# CITY OF SACRAMENTO

- SUBJECT: 1. Final Environmental Impact Report on Del Paso Park Master Plan Implementation Program
2. Del Paso Regional Park Revised Master Plan

RESOLUTION ADOPTING THE FINAL ENVIRONMENTAL IMPACT REPORT  
FOR THE DEL PASO REGIONAL PARK MASTER PLAN IMPLEMENTATION  
PROGRAM AND THE REVISED DEL PASO  
REGIONAL PARK MASTER PLAN

DEL PASO PARK MASTER PLAN IMPLEMENTATION PROGRAM EIR

McCLELLAN AFB  
PLANNING BOUNDARY  
MAP

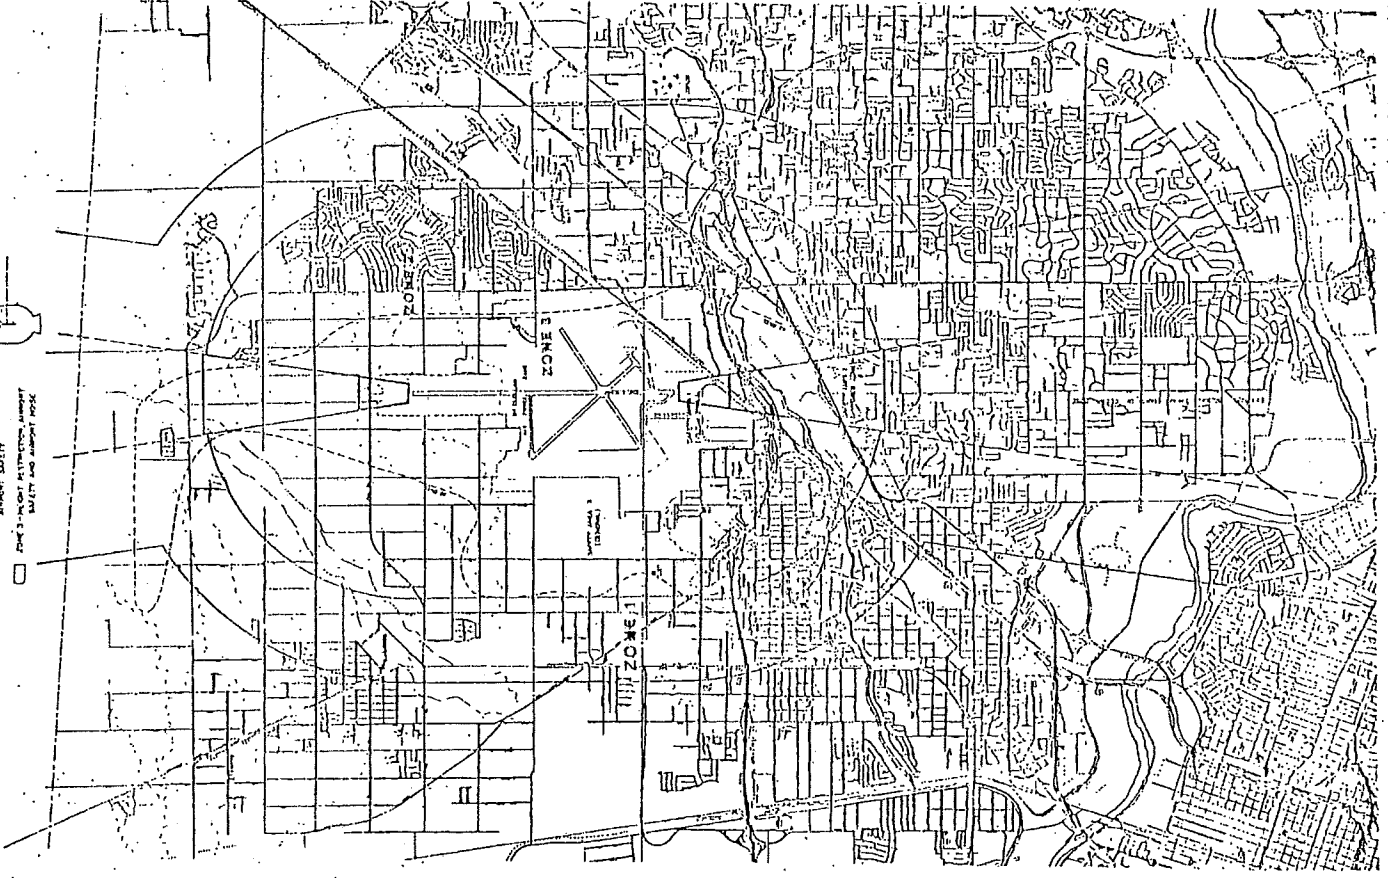
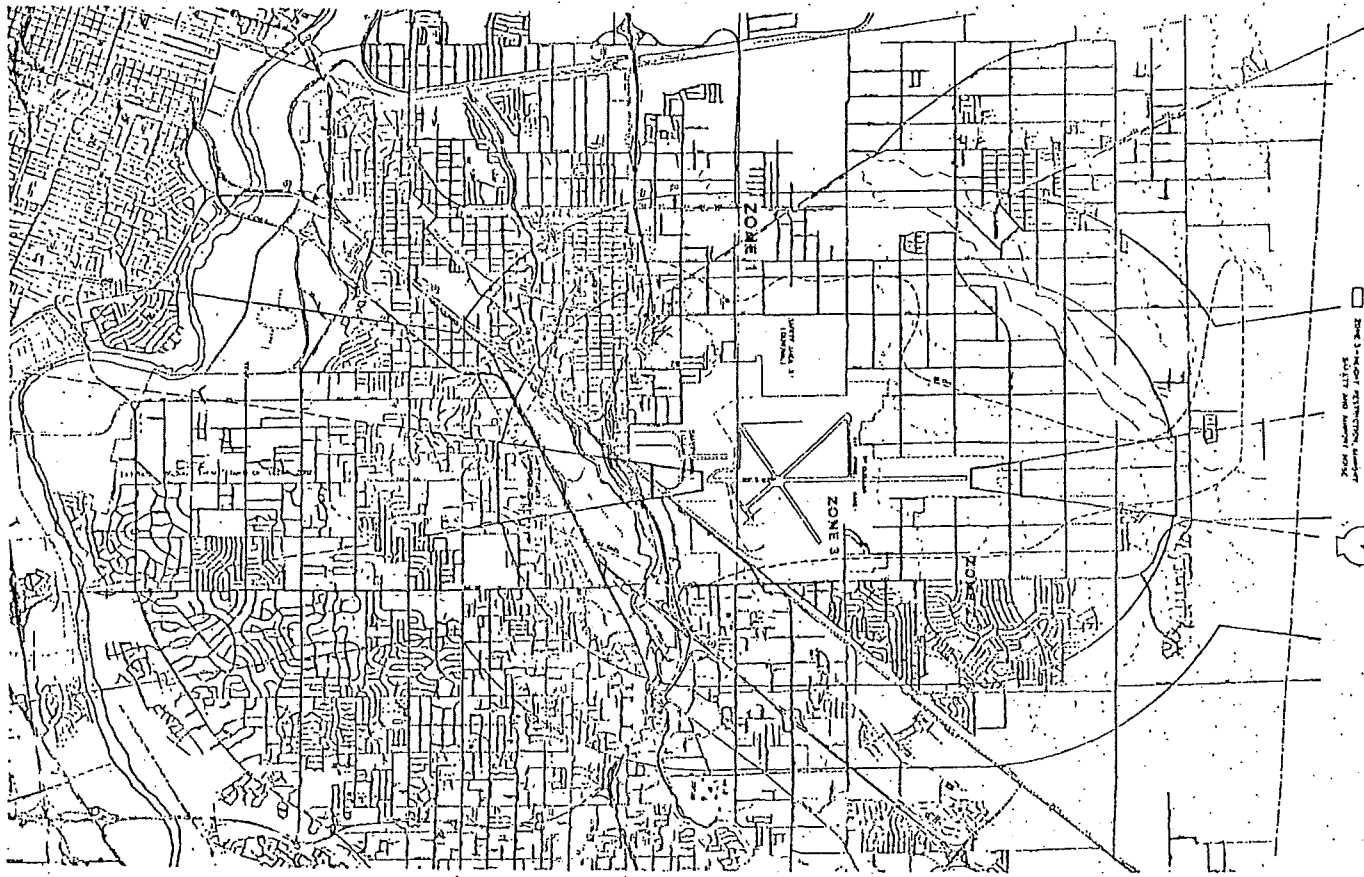
1. Revised Exhibit D-2 (p. 10) now titled "ALUC Constraints (Revised)" is incorrect. This map shows clear zone, approach zone and noise contours from the McClellan AFB Air Installation Compatible Use Zone (AICUZ) Study and not the ALUC planning boundaries for McClellan. An ALUC planning boundary map for McClellan is enclosed.

Revised Exhibit D-2 was incorrectly labeled. The map showed McClellan AFB Air Installation Compatible Use Zone (AICUZ) information rather than ALUC planning boundaries. The ALUC map has been printed along with the comment letter for clarification of this error.
